# SERVICE BULLETIN

NUMBER: M20-219-1

**SUBJECT:** PROPELLER SPINNER BULKHEAD INSPECTION  
AND MODIFICATION

**MODELS  
AFFECTED:** M20J S/N's 24-0001 thru 24-0786

Figure 1

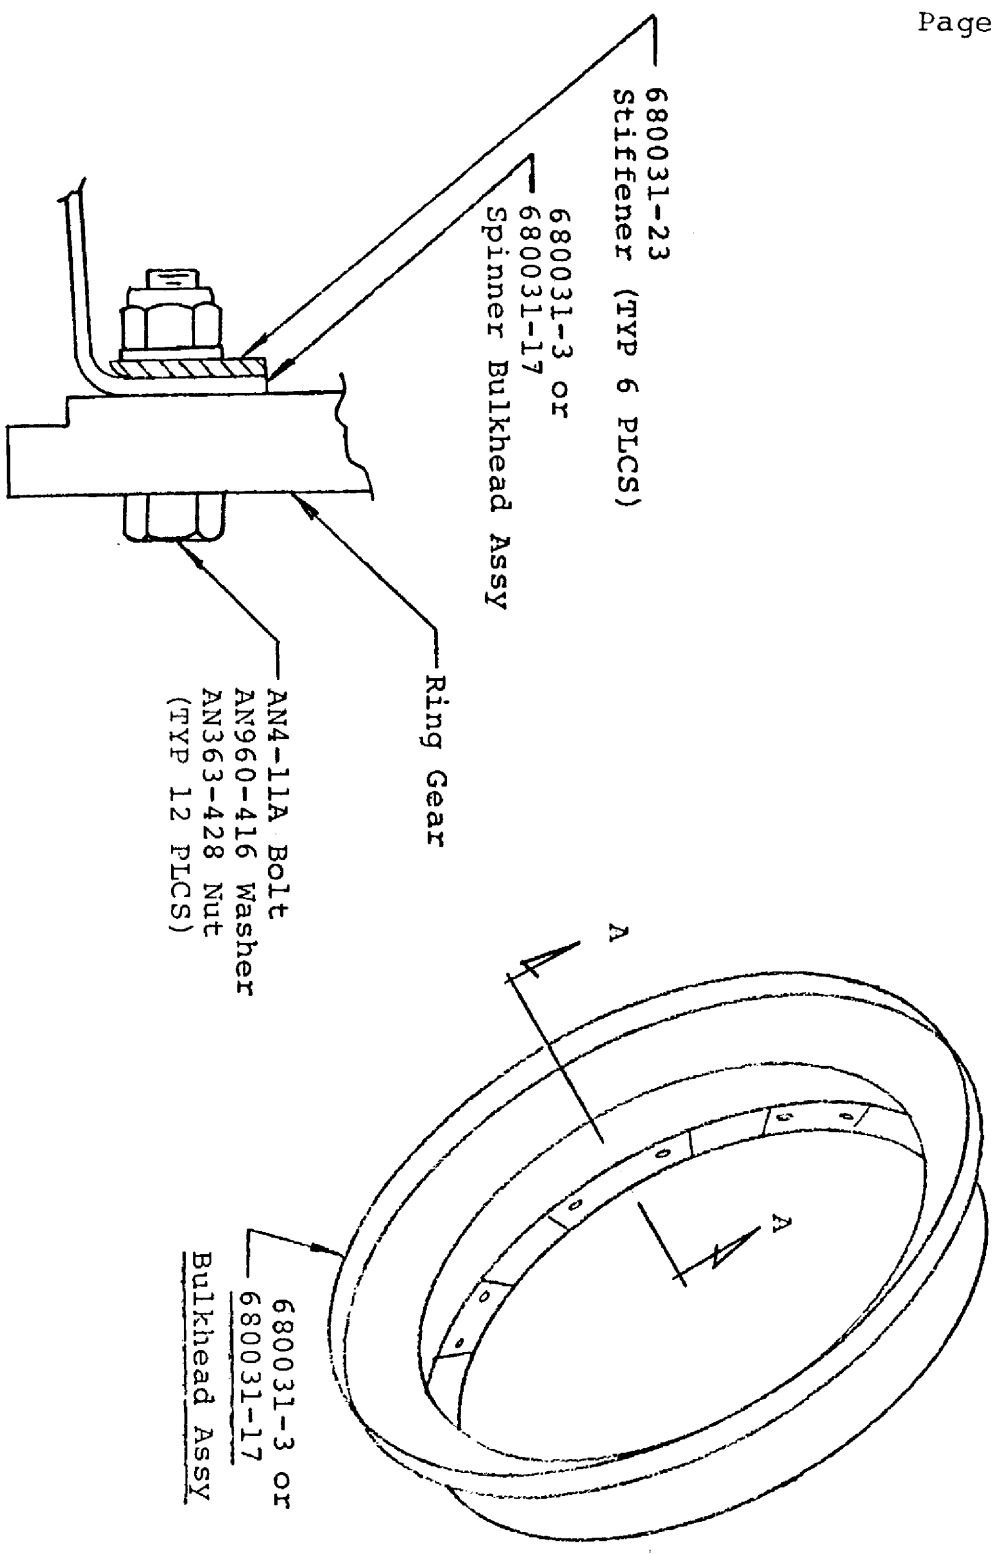
**INTRODUCTION:** In order to prevent the possibility of cracking  
of the 680031-3 or -17 spinner aft bulkhead  
assembly around the attachment bolts, the  
following inspection and modification should  
be implemented.

1. Remove the 680031-7 or -19 propeller spinner.
2. Remove the propeller assembly.
3. Remove (12) AN4-10A bolts attaching  
680031-3 or 680031-17 bulkhead assy to  
the engine ring gear.
4. Inspect 680031-3 or 680031-17 bulkhead  
assy for cracks; if cracked, replace bulkhead.  
If no cracks are found, proceed with instal-  
lation of Service Bulletin stiffeners  
680031-23 (6 each as shown in Figure 1).
5. Reinstall propeller and spinner removed per  
Steps 1 and 2 with existing hardware. (Torque  
all bolts to specified torque. AN4-11A 50 to  
70 in-lbs., prop attach bolts 55 to 65 ft-lbs.,  
and spinner screws 30 in-lbs. +5 in-lbs.).

**CAUTION:** The forward spinner bulkhead should have a  
snug fit on the propeller dome. Install  
6.5 MIL x .50 wide "Scotch Brand" No.  
549 pressure sensitive tape, mfg. by 3M  
Co., St. Paul, Minnesota, on propeller  
dome as required to provide a snug hand  
press fit.
